Village of Bellevue
Plan Commission Meeting
TUESDAY, JUNE 15, 2021
Village Hall/Public Safety Building
3100 Eaton Road
6:00 PM

PLAN COMMISSION MEETING OF 6/15/2021 AGENDA ITEM PLAT 2021-0001

PLAN COMMISSION MEETING OF 6/15/2021 AGENDA ITEM PLAT 2021-0003

PROJECT NO.
K-16805
SHEET NO.
1 of 2
DRAWING NO.
P-2480

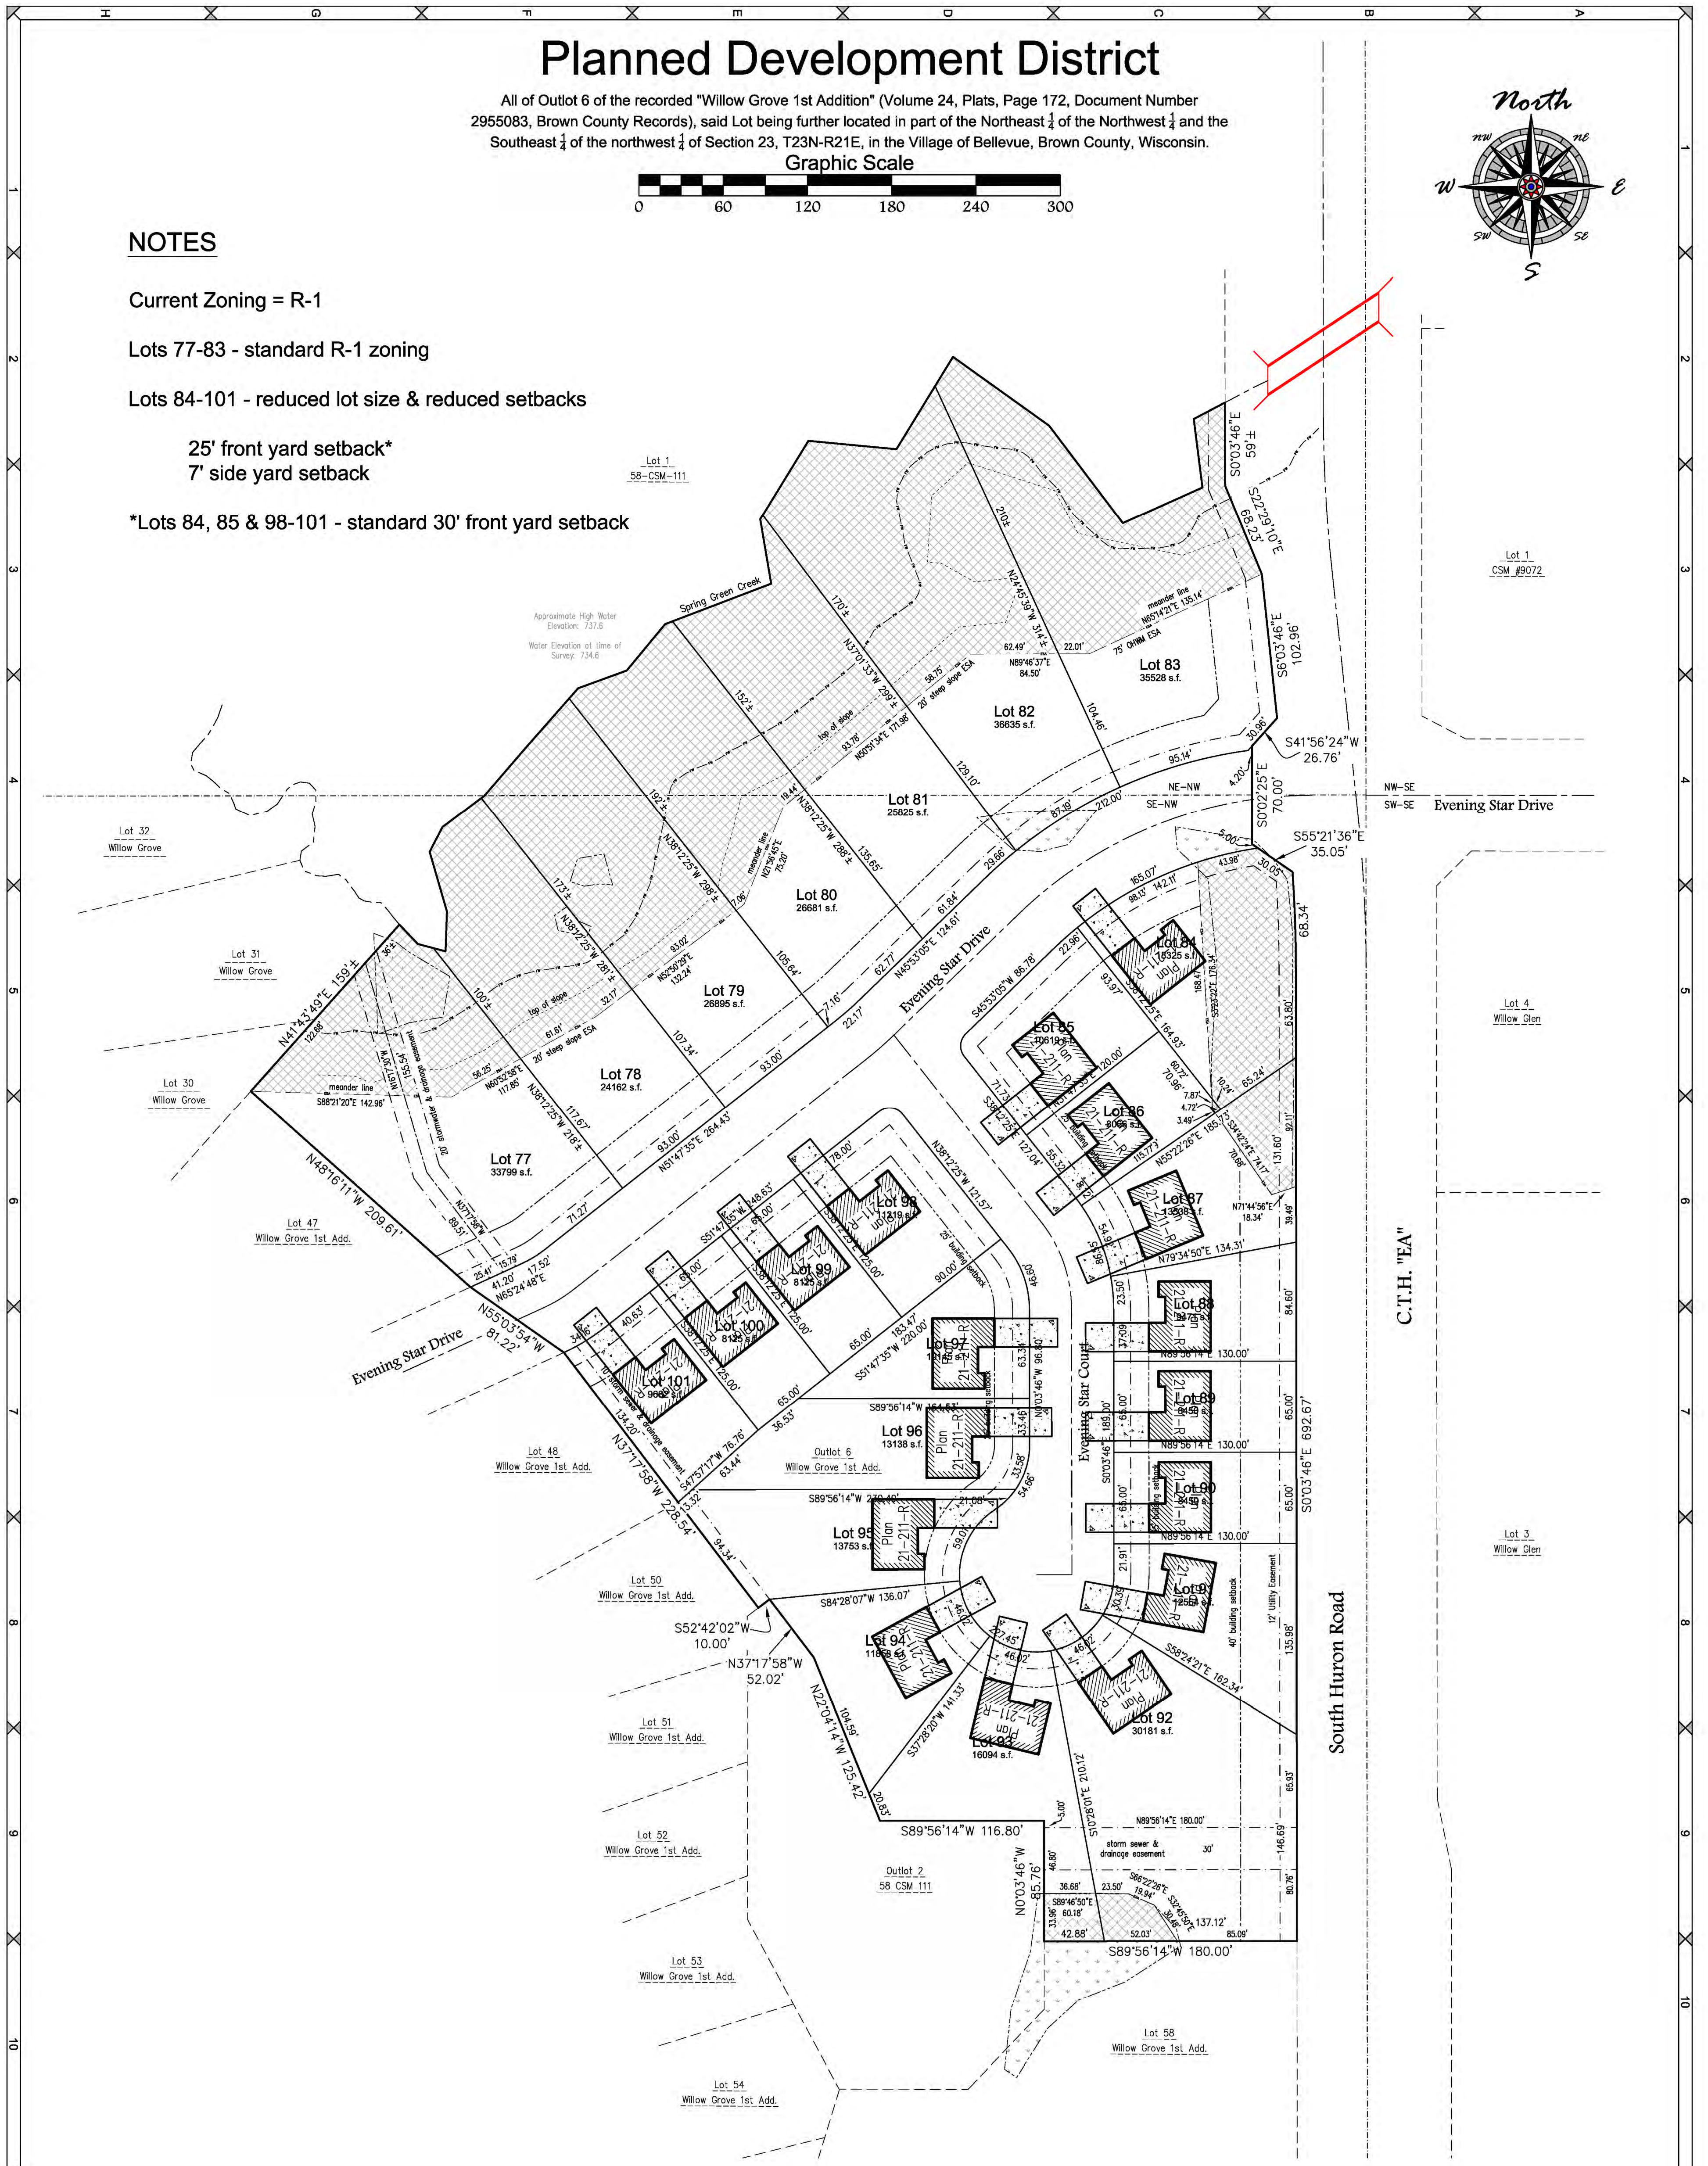
1. A Final PDD shall be submitted for review and approval by the Village Board within a year of approval of the Preliminary PDD.
2. The underlying zoning of the R-1 – Single-Family Residential District standards shall apply except deviations approved within the Final PDD.
3. Exterior color choices shall be required among the neighborhood in order to provide variation.

DRAWING NO.
P-2479

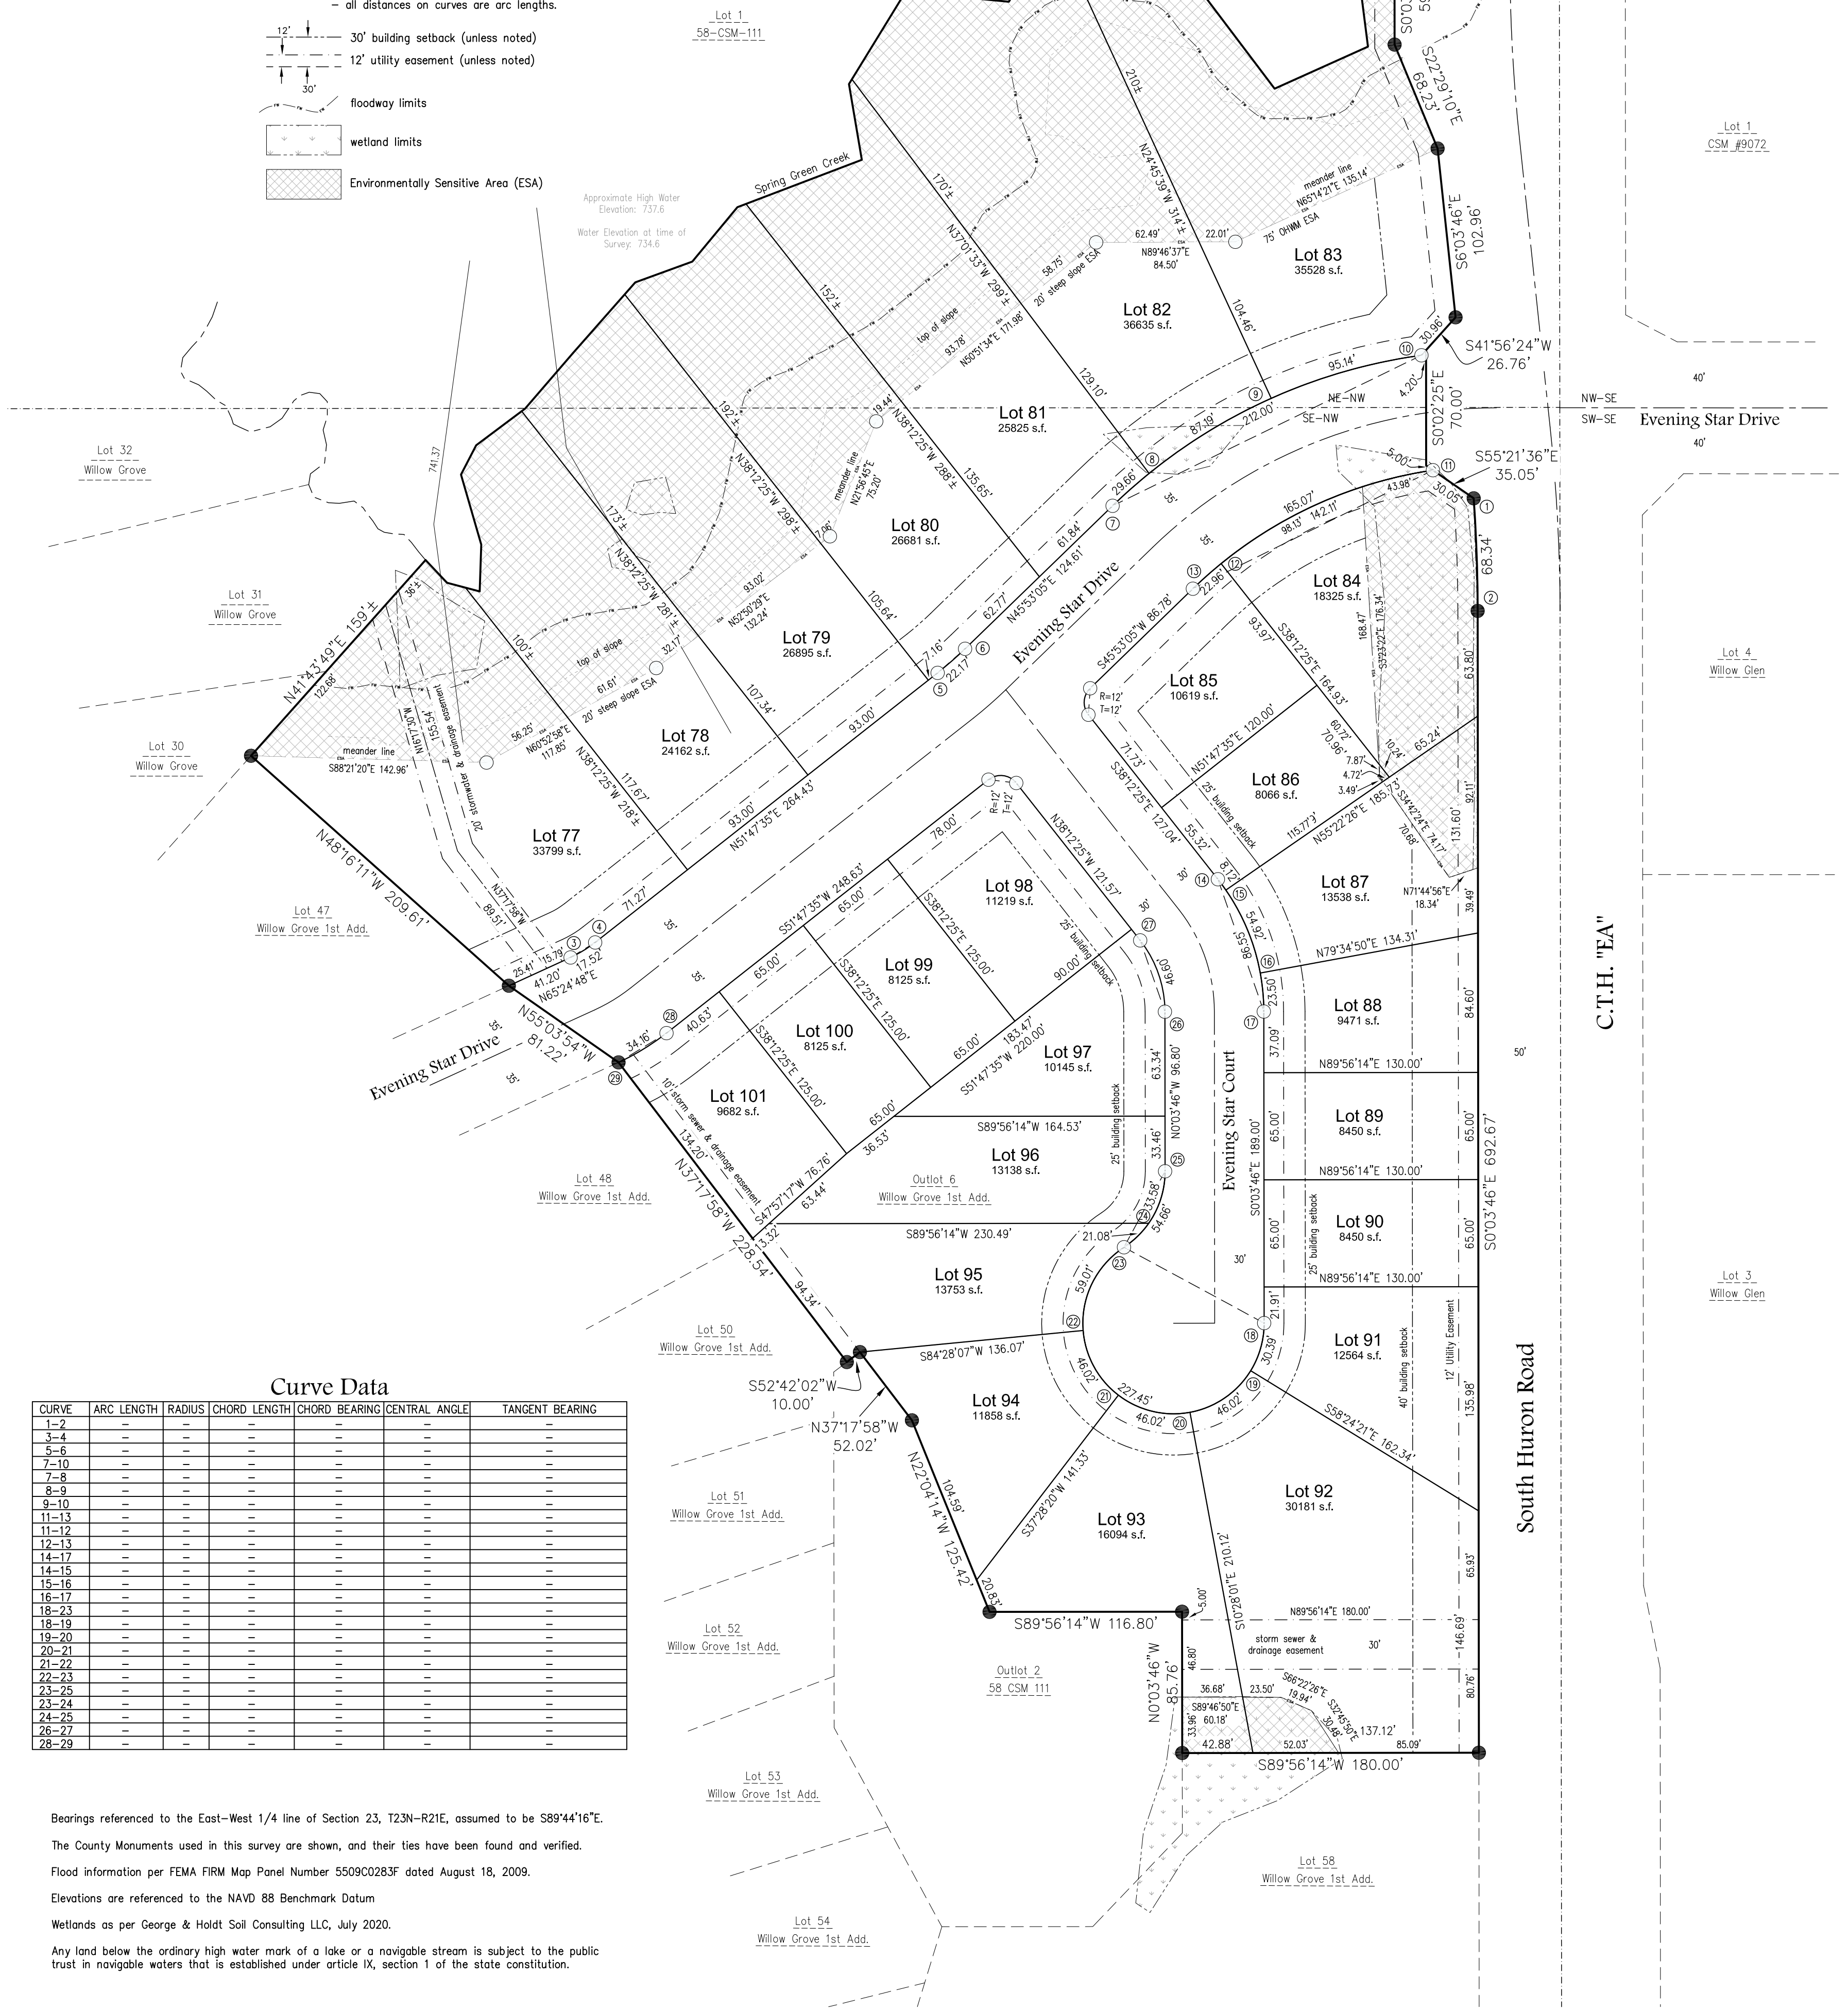
4. Submission, review, approval, and signature from Brown County Planning Commission.
5. All easements as required by reviewing agencies.
6. Label the utility easement and front yard setback distances on the lots north of Evening Star Drive.

7. Provide a grading and drainage plan subject to review and approval by Director of Public Works.
8. Approval of a reduction of right-of-way width for Evening Star Court from 70' to 60'.

9. Provide the radius for the cul-de-sac on the plat.
10. Amend the plat to identify the 30' storm sewer and drainage easement to add access for pond maintenance.

11. Add a note regarding obstructions within the 30' storm sewer, drainage and access easement for Lot 92 on the plat.
12. Add a note and symbol to the plat that indicates that no access will be permitted to Huron Road (County Highway EA) from Lots 83, 84 and 87 through 92.

Staff questions the name Third Addition as there was the original Willow Grove subdivision and the First Addition that is directly to the west. Although this is the 3rd plat of the Willow Grove subdivision, it is the second addition to the original and therefore would recommend it be renamed to the Second Addition.

Court. A note shall be added to the plat that indicates proposed Lots 83, 84 and 87 through 92 shall not be permitted access to Huron Road (County Highway EA) and provide a

DRAINAGE: The applicant/owner will be responsible for working with the Village of Bellevue on all drainage associated with the subject property, and for compliance with the Village of Bellevue Storm Water Ordinance. An existing stormwater pond is directly south of the proposed plat. This was installed when Huron Road (County Highway EA) was urbanized to take into account the road as well as future adjacent development. The applicant shall verify that the pond can accommodate the proposed development as it was designed and provide any necessary easements. Also, the 30' wide storm sewer and drainage easement shall be amended to include access as the Village owns the pond but will need to ensure access is permitted for any future maintenance needs. As it would be an access easement, no fences or obstructions will be permitted within the easement of proposed Lot 92 and staff recommends a note be added to the plat. Staff will need to review if an easement will be needed to be added along the rear of Lots 93 & 94 for maintenance and access to the stormwater pond as well.
